RETAINING WALL AT PORT CARLING
WP 401-64-02, HWY 118
DISTRICT # 11 - HUNTSVILLE

Re: Retaining Wall at Port Carling
W.P. 401-64-02, Hwy. 118
District 11, Huntsville

W.P. 401-64-02, HIGHWAY 118
PORT CARLING - RETAINING WALL
DISTRICT #11, HUNTSVILLE

FOUNDATION INVESTIGATION REPORT

BORE HOLE LOCATIONS & SOIL STRATA

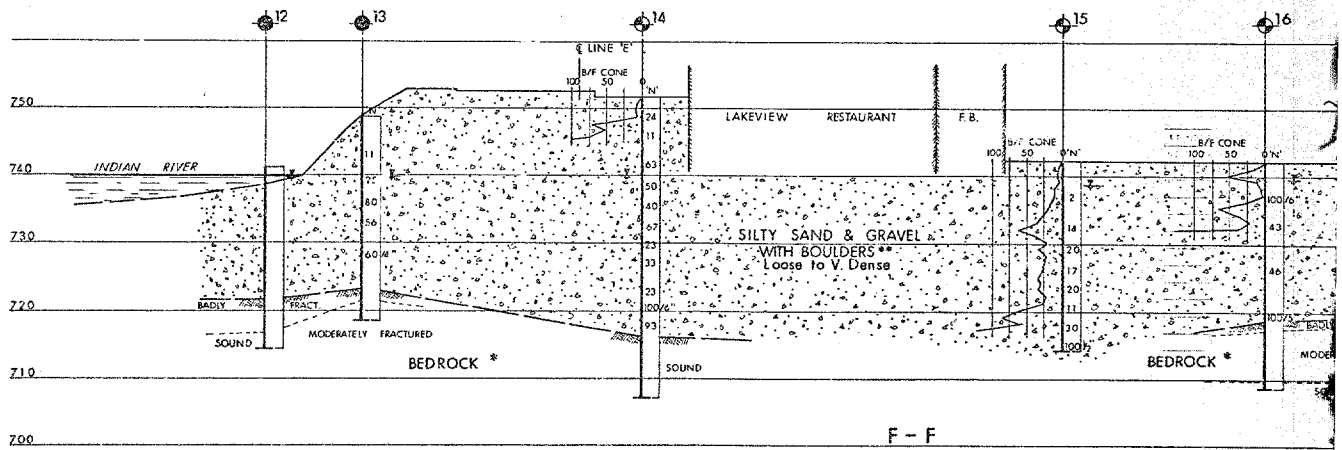
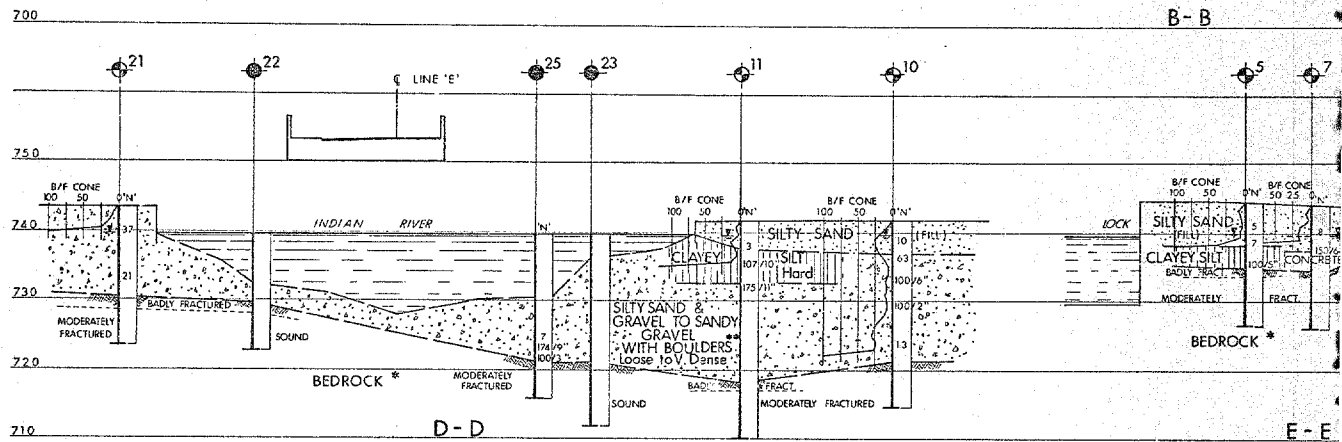
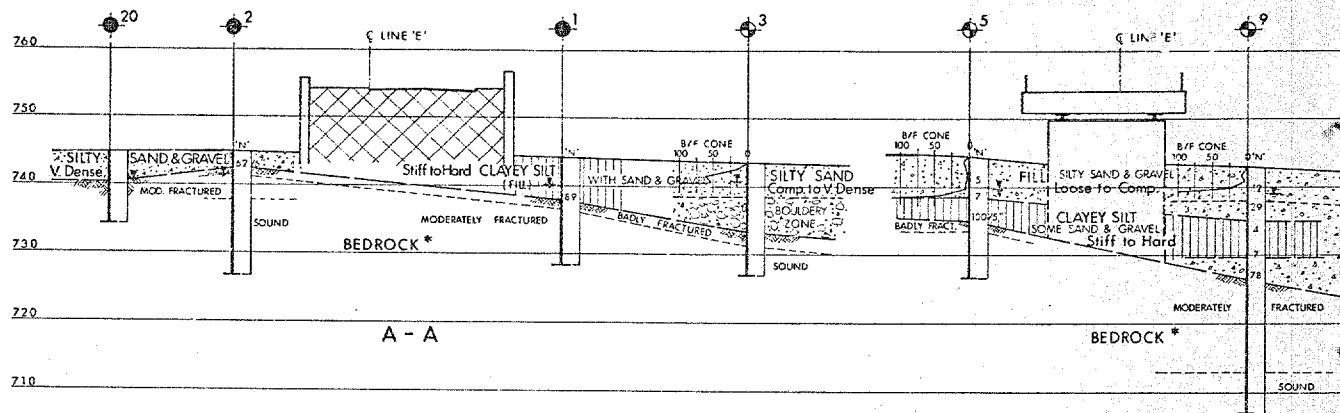
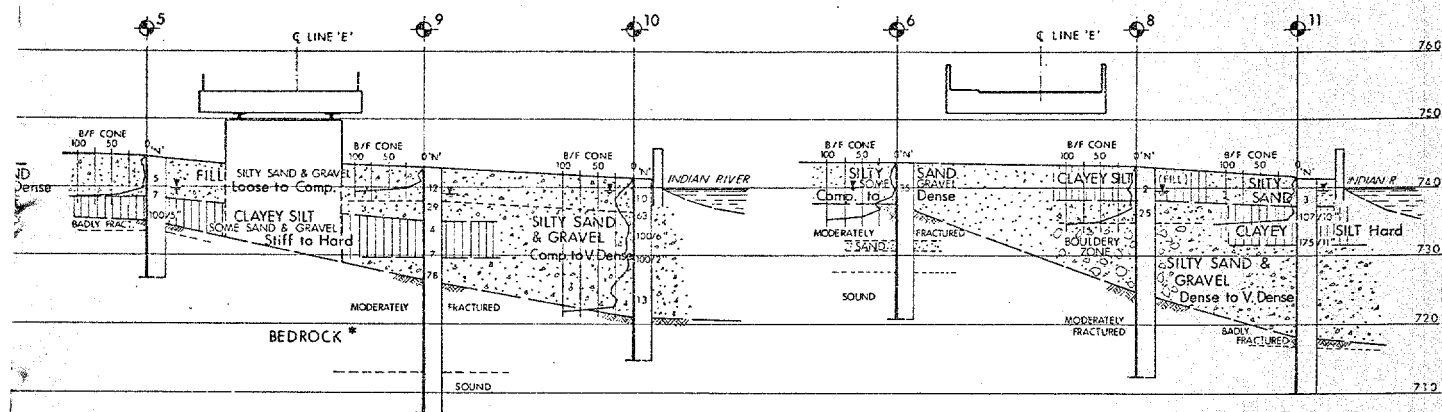
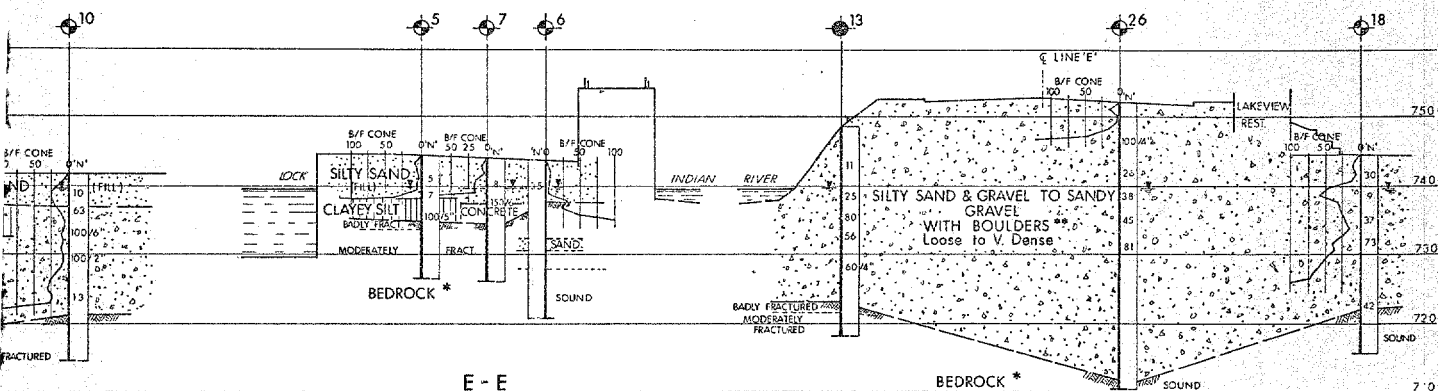
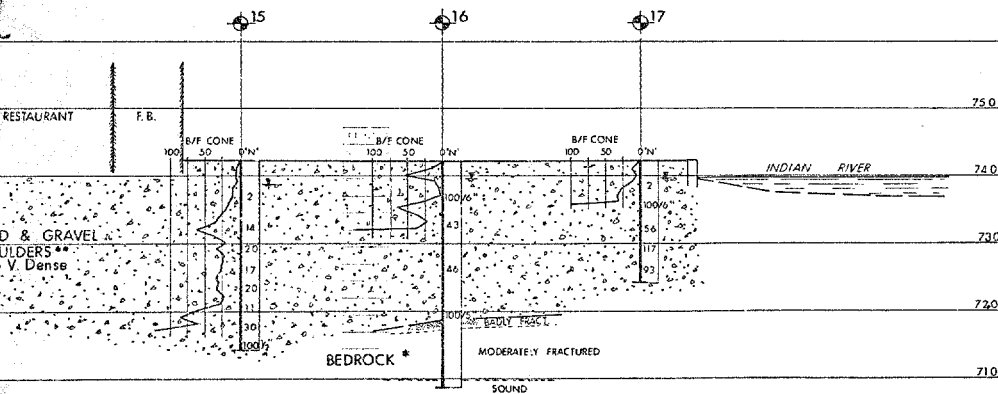
The Contractor claims that the rock encountered in the vicinity of B.M.'s #5-#9 inclusive, appears to be much harder than as indicated in the Foundation stratigraphical drawing.

Bridge Drawing No. 2 and No. 3 (page 30 and 31) indicate the bore hole locations and soil strata. The bascule pier area is in the section surrounded by bore holes 5, 6, 7, 8 & 9. Also refer to the Foundation Investigation Report for borehole records.

1. Contract Drawings No. 42-1-2 and 42-1-3 clearly indicate, by an asterisk notation, that for detailed bedrock descriptions the borehole log sheets should be consulted. For any contractor to ignore this notation and invitation to examine the detailed description of the bedrock is to scorn the value of the information willingly made available by this Ministry. Therefore, no further comment need be made either on point number 1 or point number 4 of Mr. Hallam's letter. Let's keep the additional fact in mind that all bidders were advised by special provision, of the availability of a complete soils investigation report on the contract.
